STORMWATER IMPACT ANALYSIS

ARDEN SENIOR LIVING CENTER / SPEC-23422 / DECEMBER 2023

ARDEN SENIOR LIVING CENTER

PRELIMINARY STORMWATER IMPACT ANALYSIS

Wet Pond A

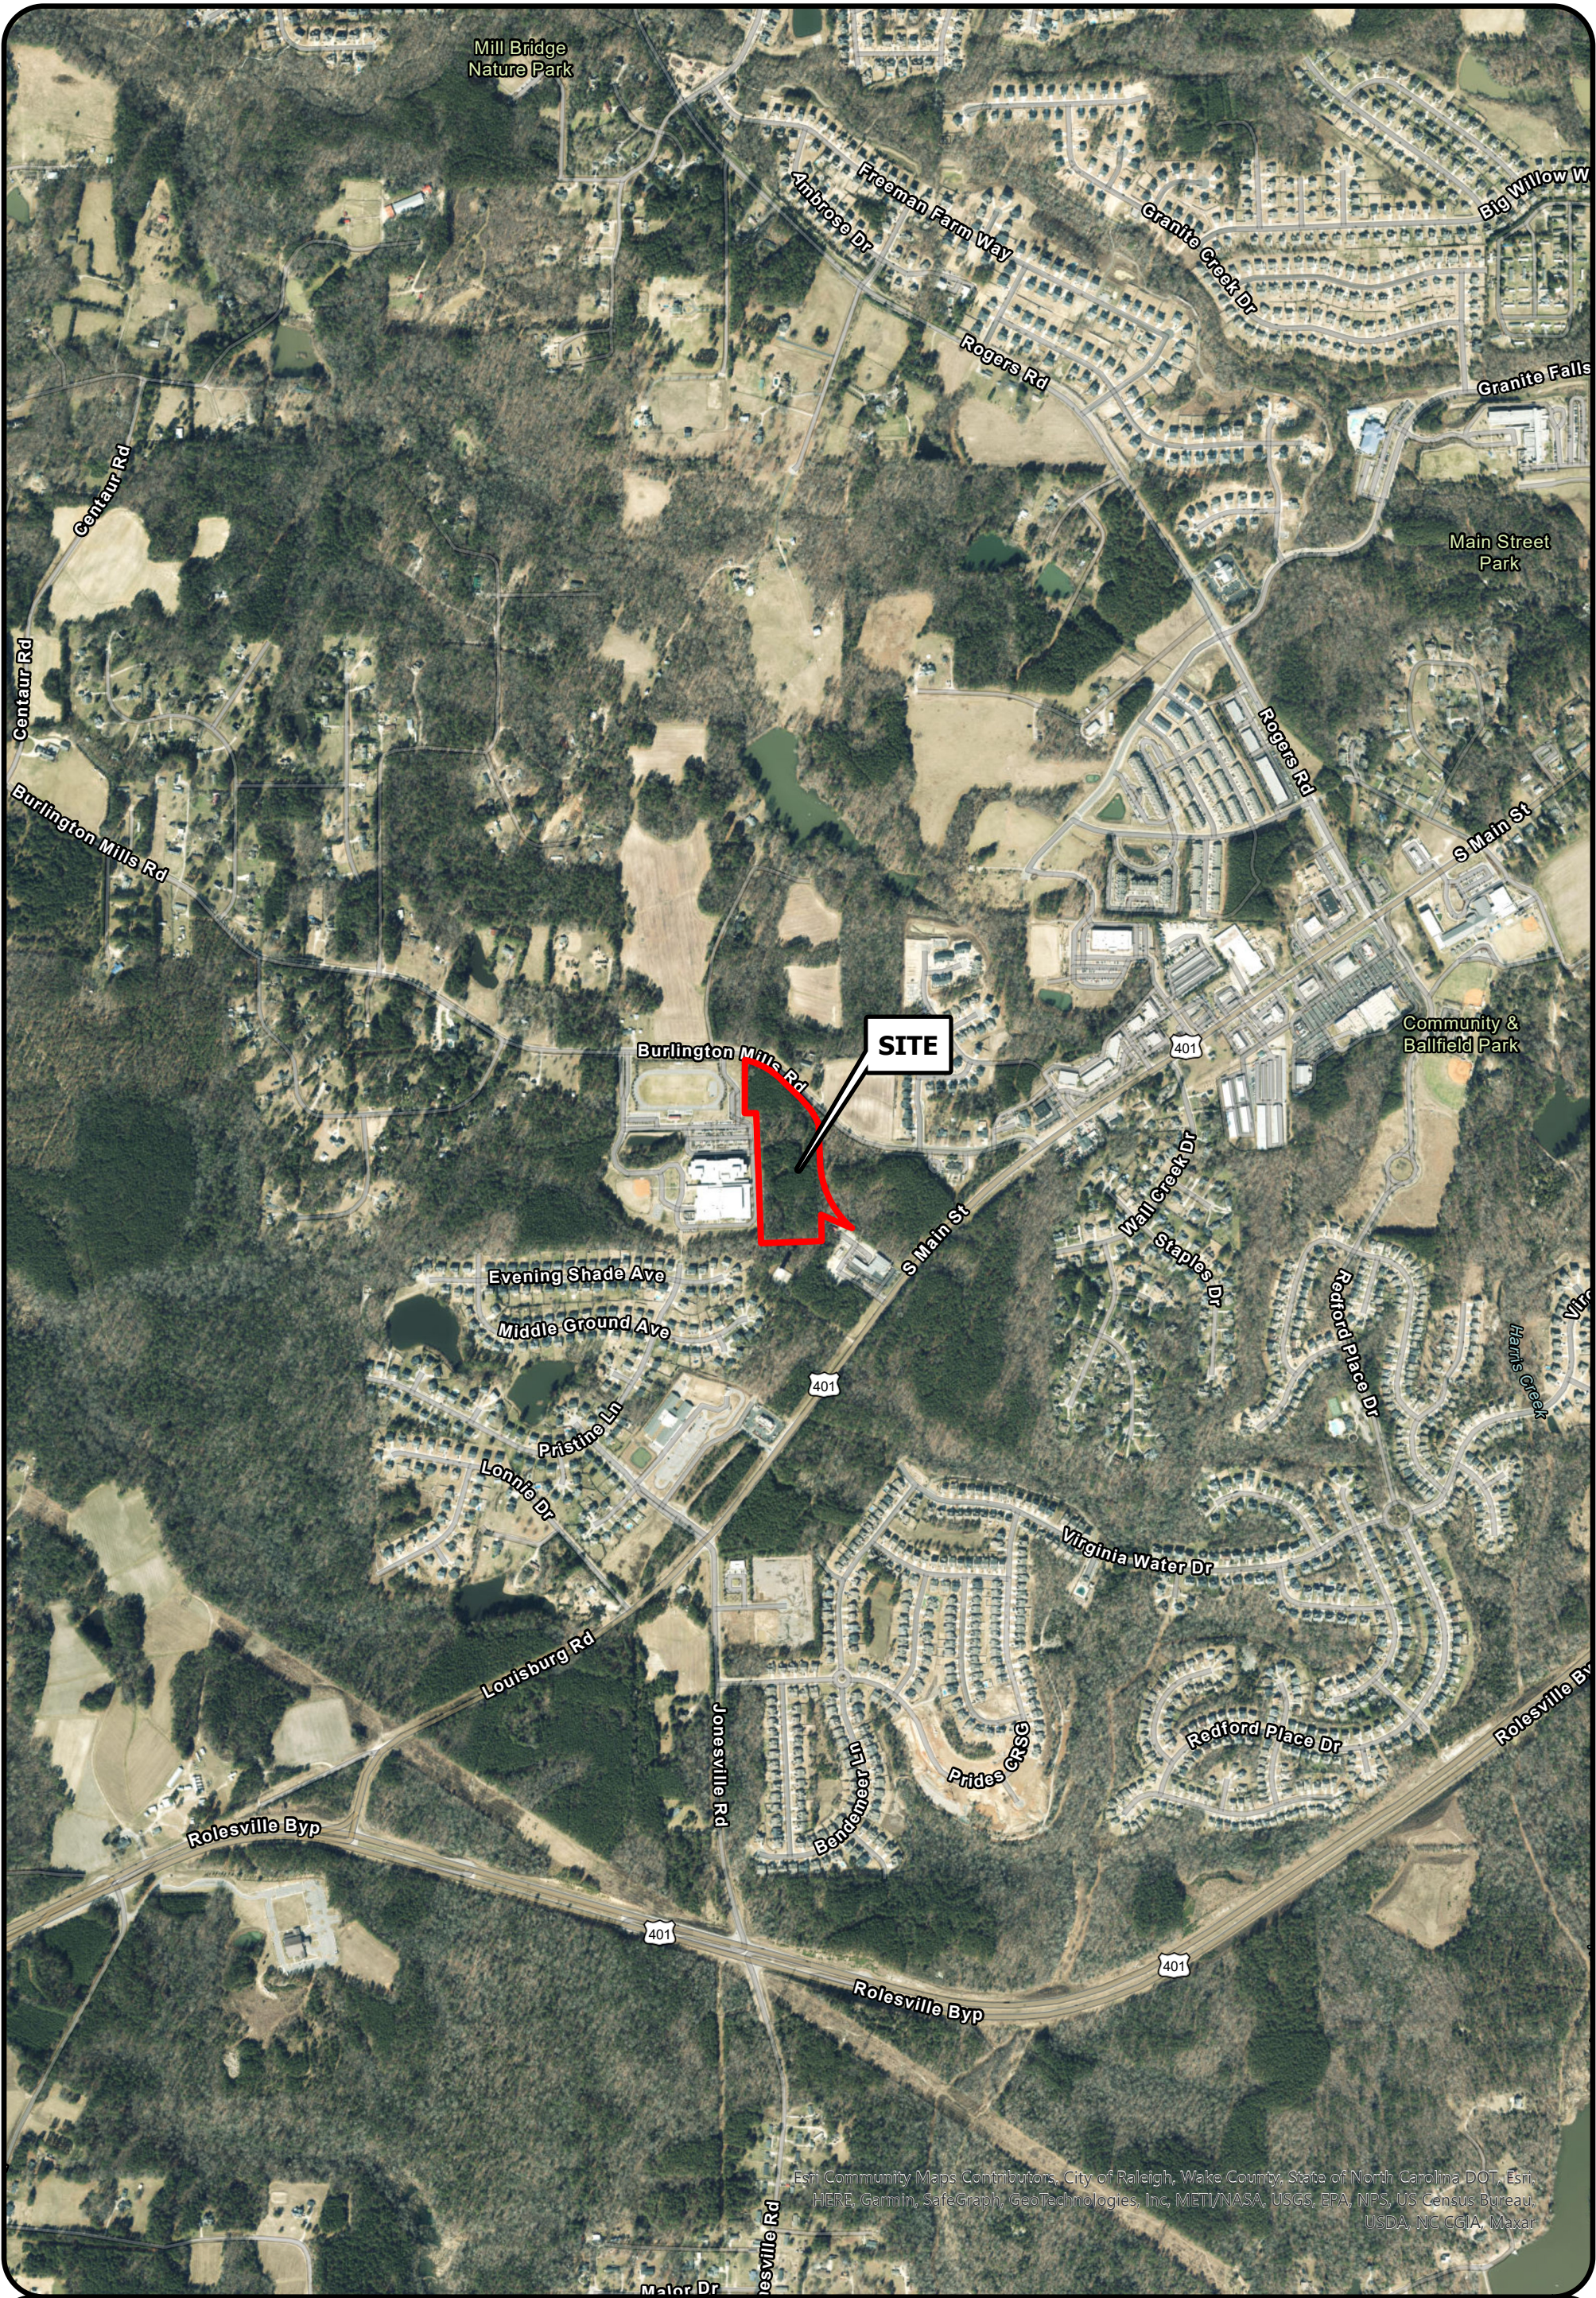
50.) Does not match the cover

50.) Is this due to the additional roadway drainage being captured and routed to the pond? Provide Drainage area map of impervious to verify values.

51.) The Top of the dam is designed to over top your retaining wall for your 100 year storm. Revise so the wall is not over topped.

**ARDEN SENIOR LIVING CENTER
PRELIMINARY PLAT PLAN**
ROLESVILLE, NORTH CAROLINA

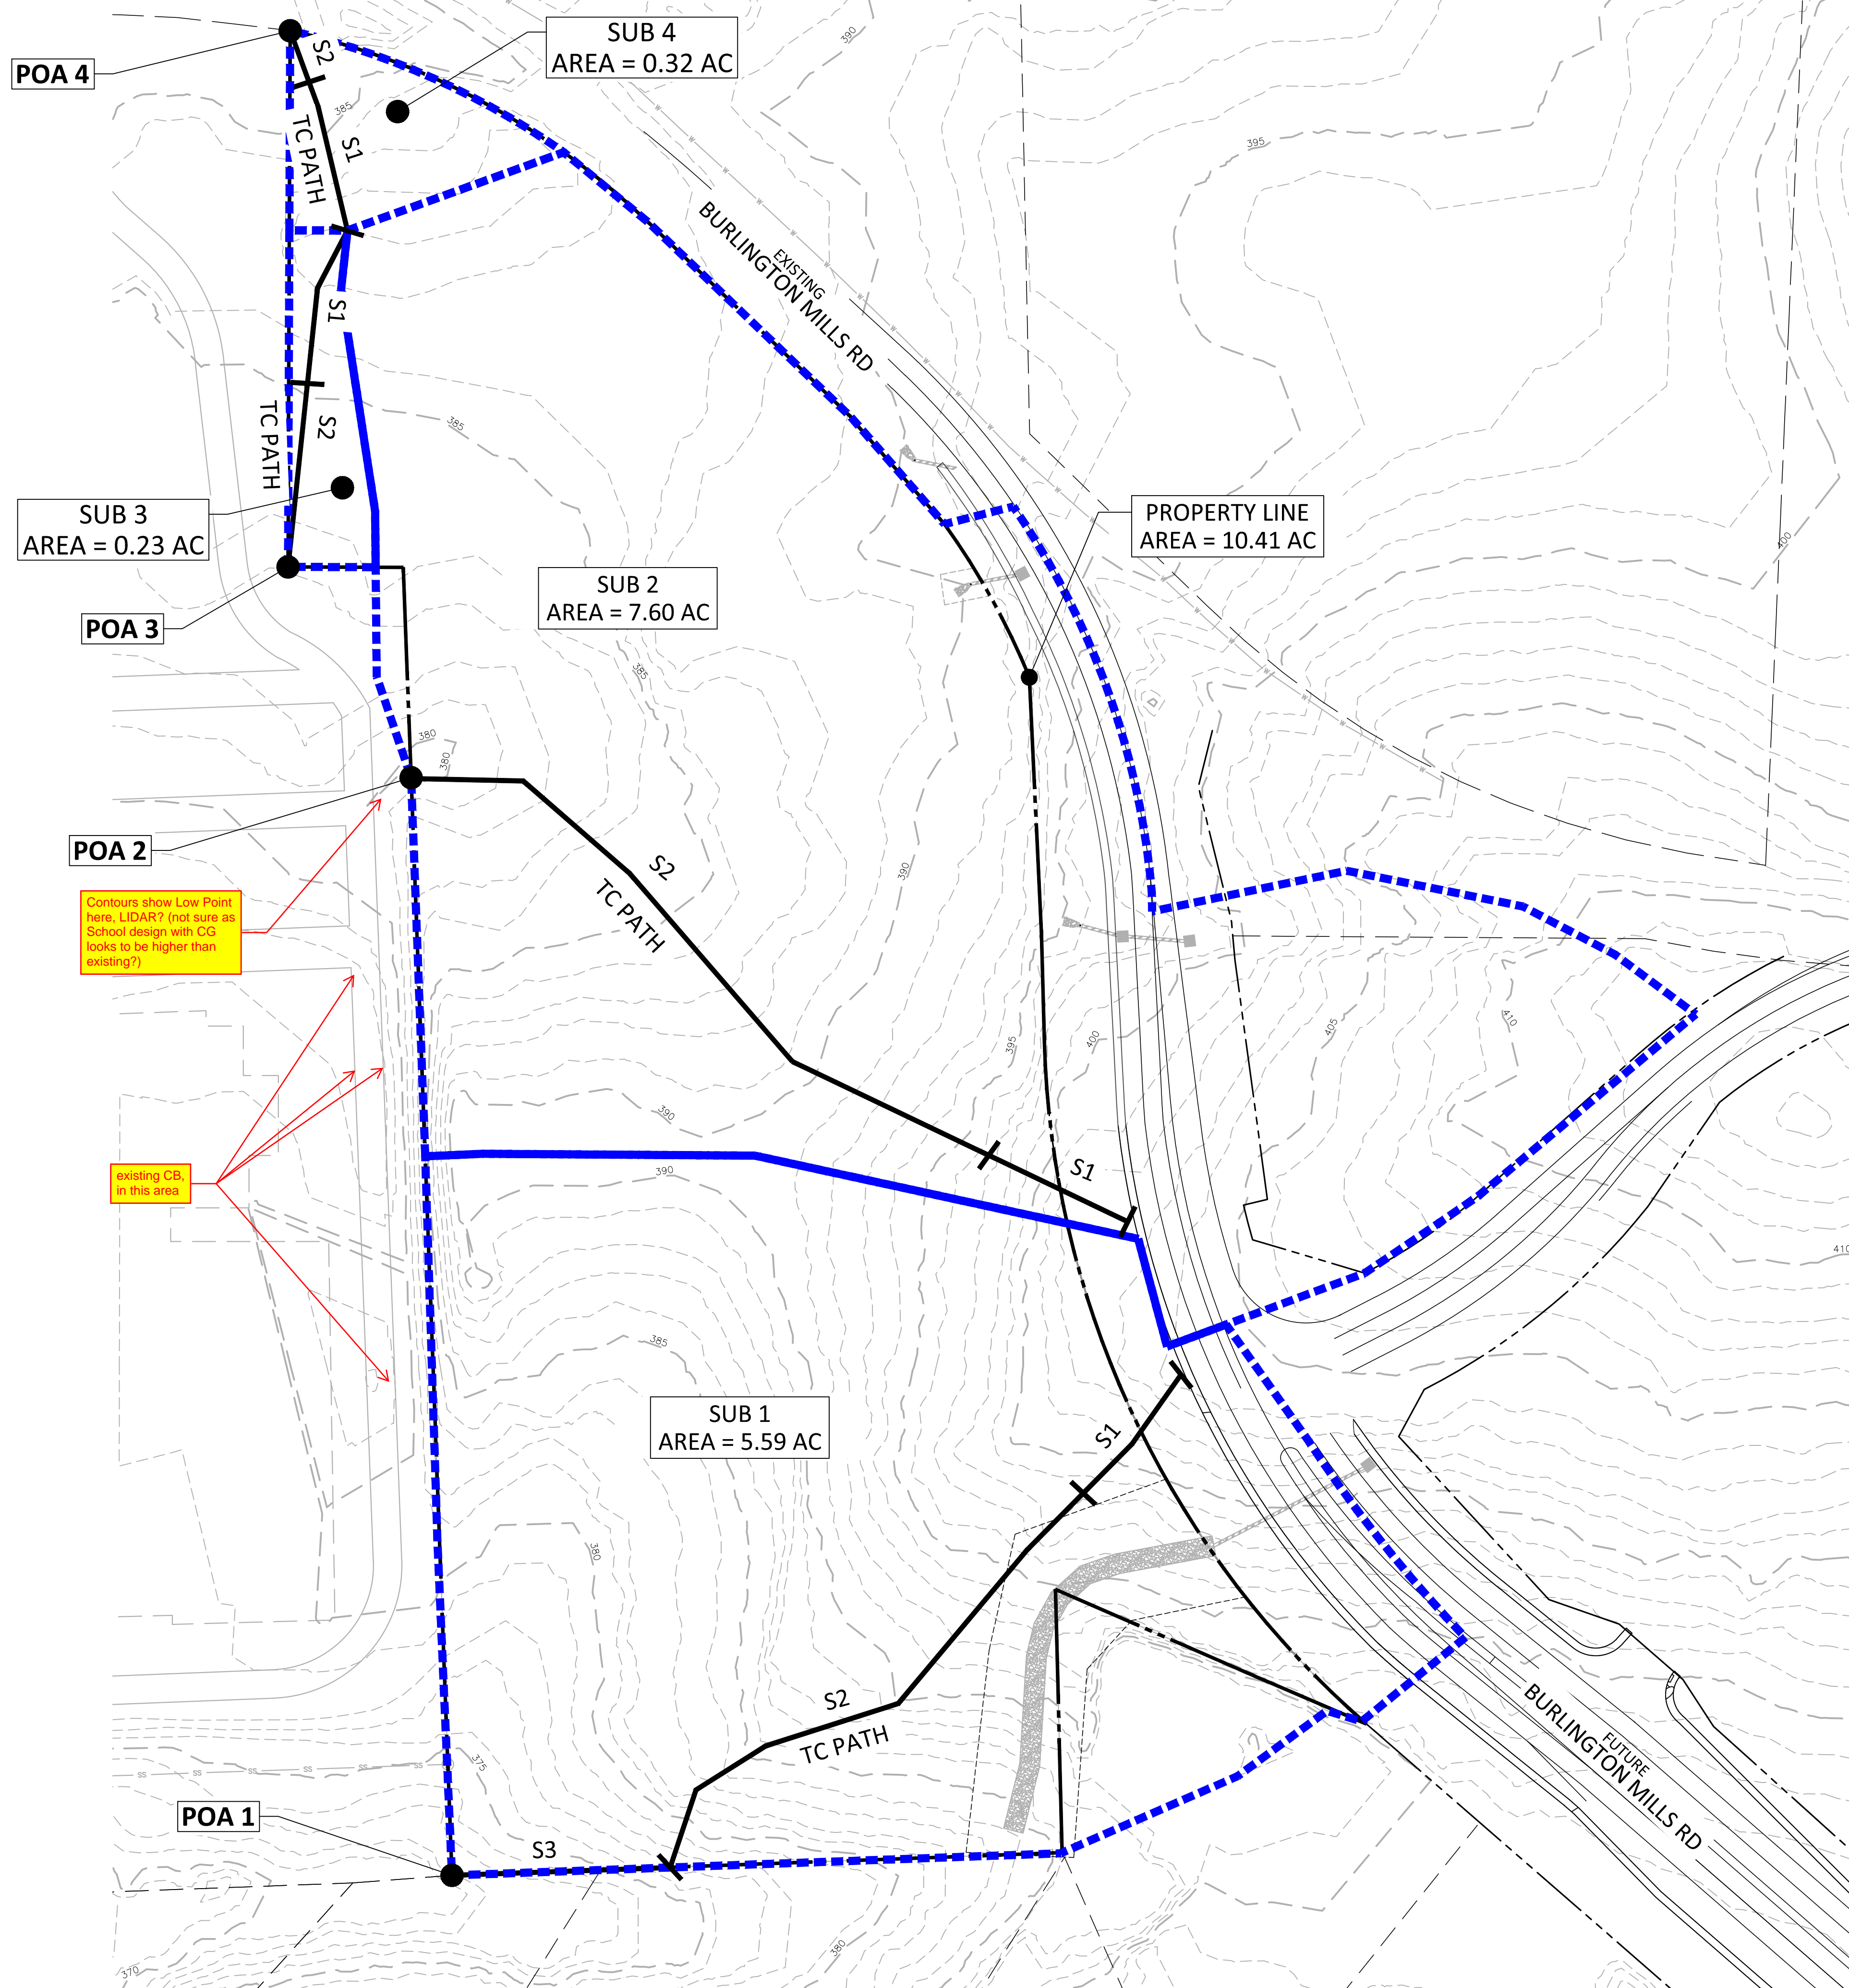
Contours show Low Point here. LIDAR? (not sure as School design with CG looks to be higher than existing?)

ARDEN SENIOR LIVING CENTER
PRELIMINARY PLAT PLAN
ROLESVILLE, NORTH CAROLINA

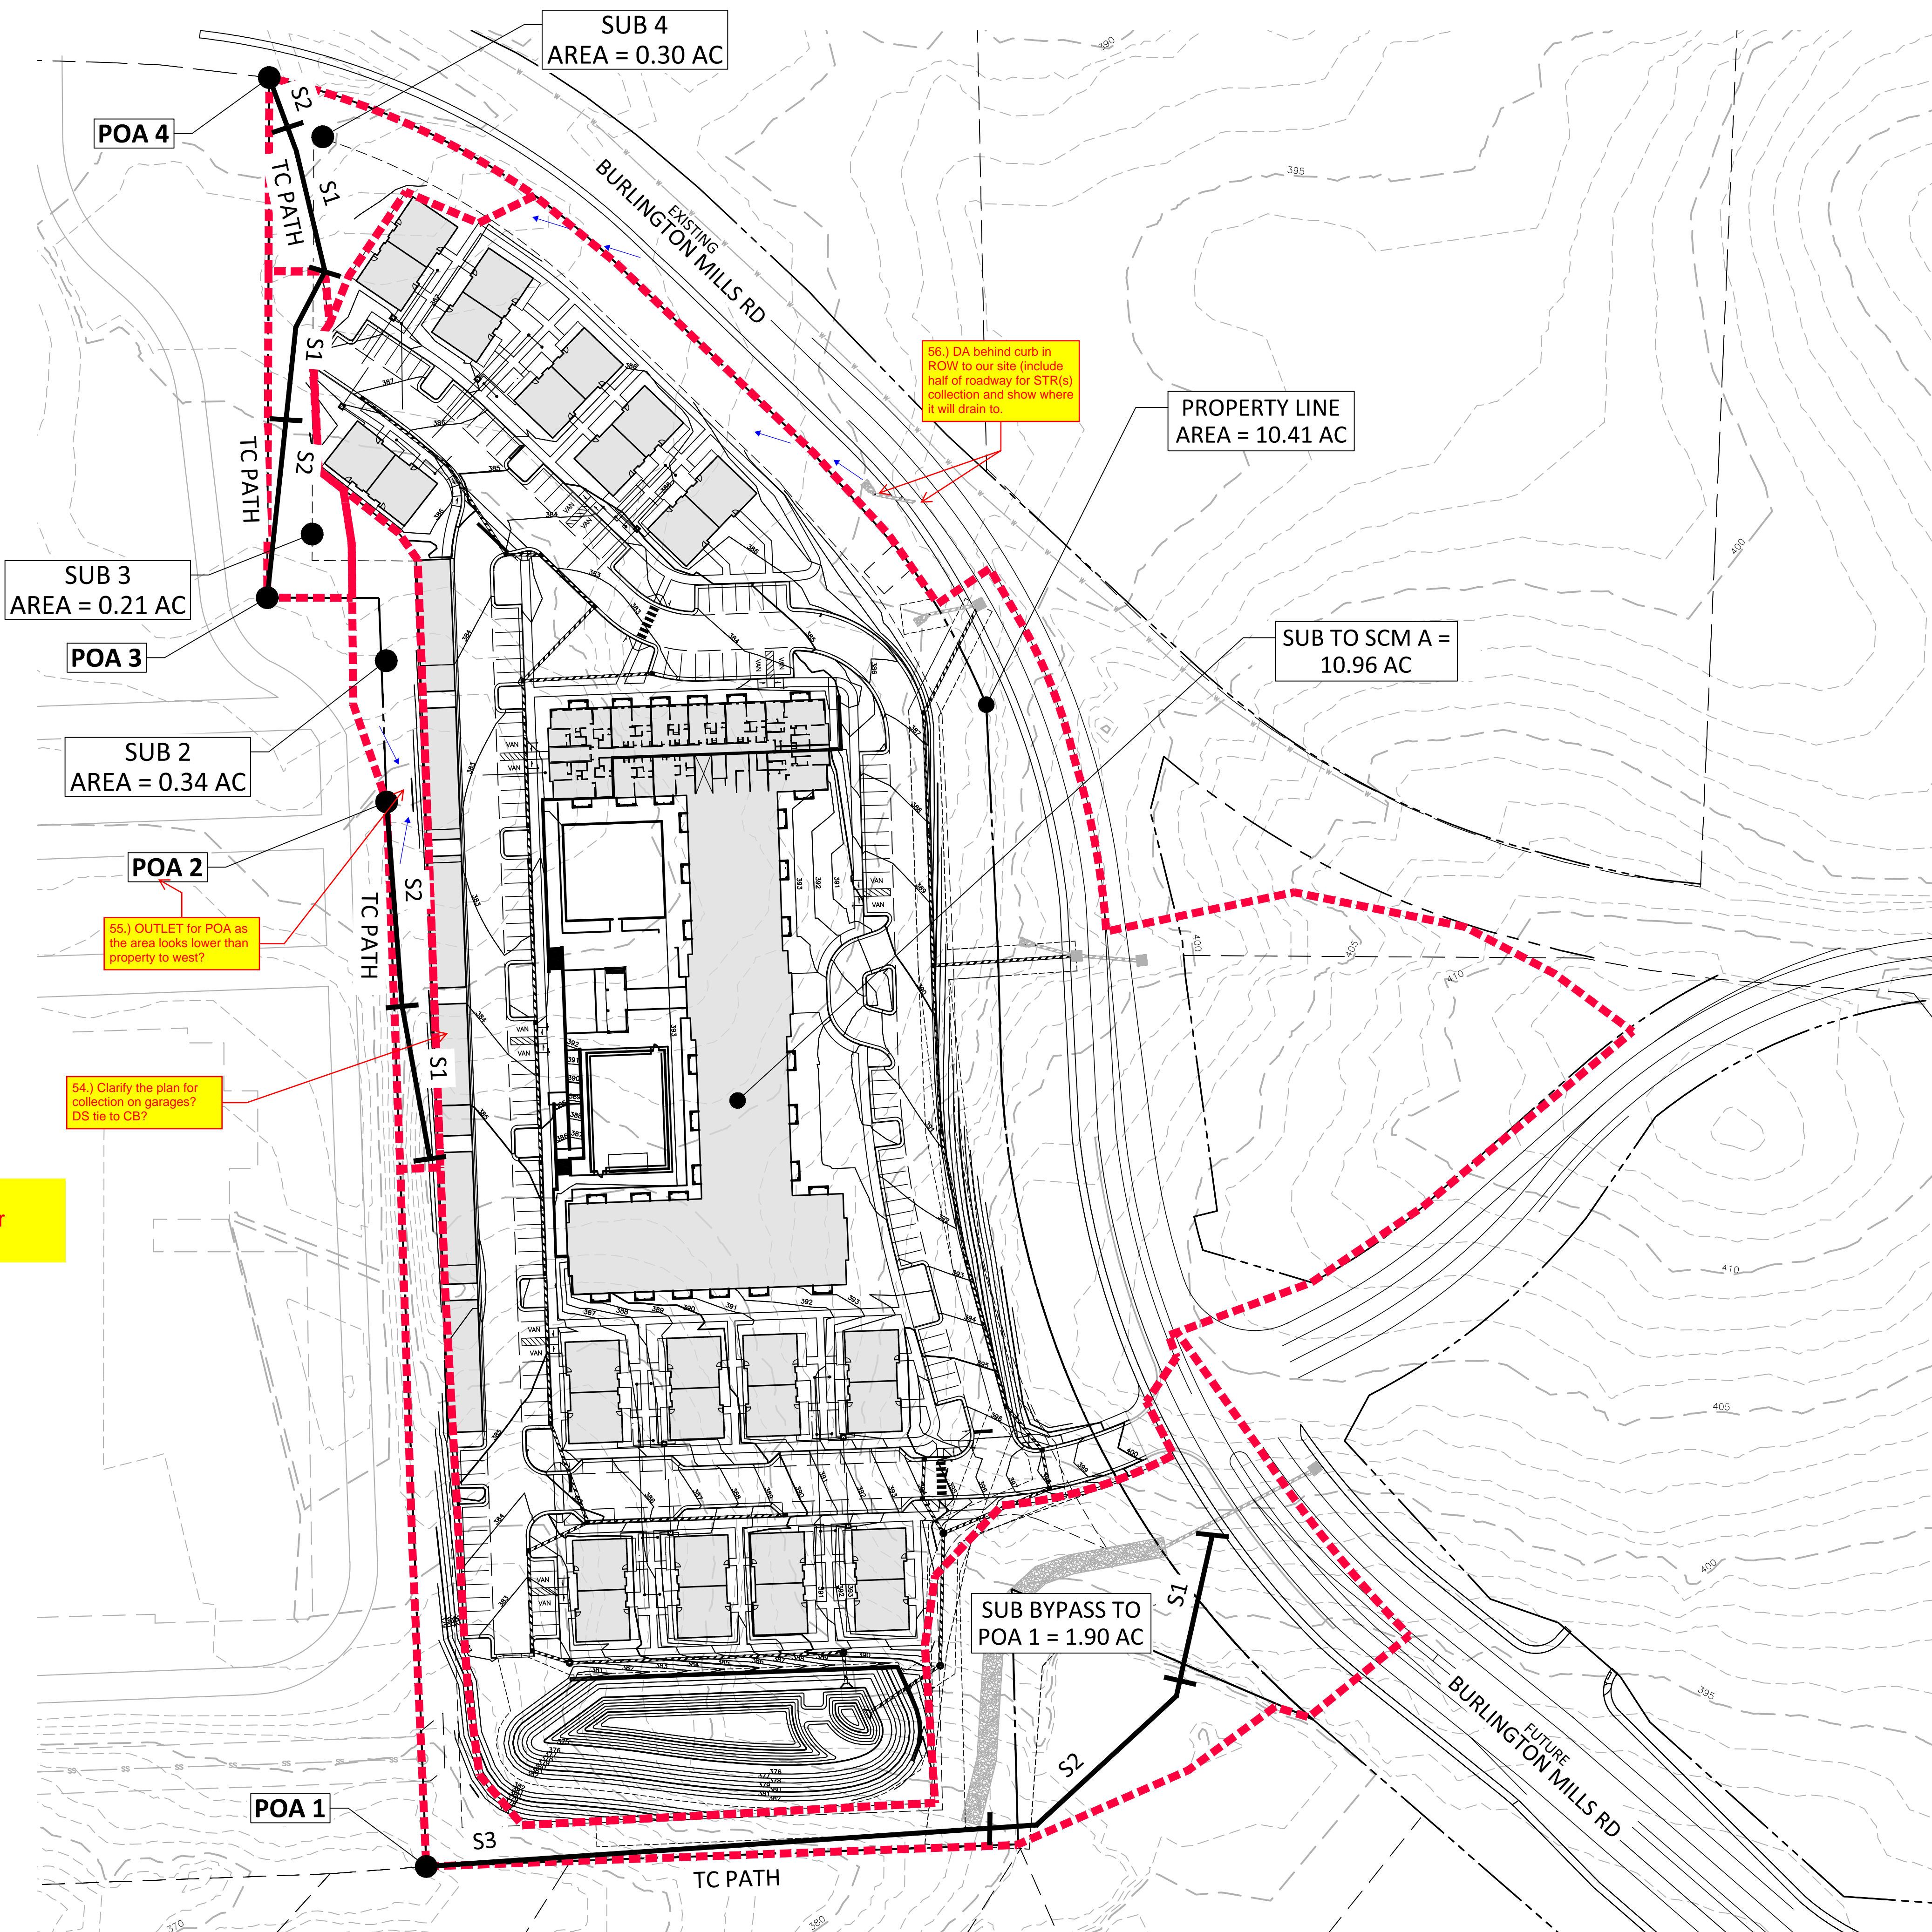
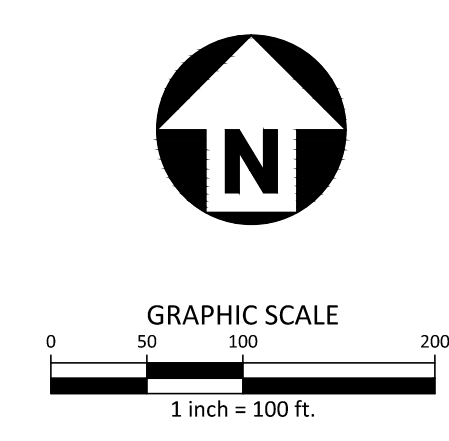
56.) DA behind curb in ROW to our site (include half of roadway for STR(s) collection and show where it will drain to.

55.) OUTLET for POA as the area looks lower than property to west?

54.) Clarify the plan for collection on garages? DS tie to CB?

53.) Include impervious areas for all drainage designed to be routed to your pond.
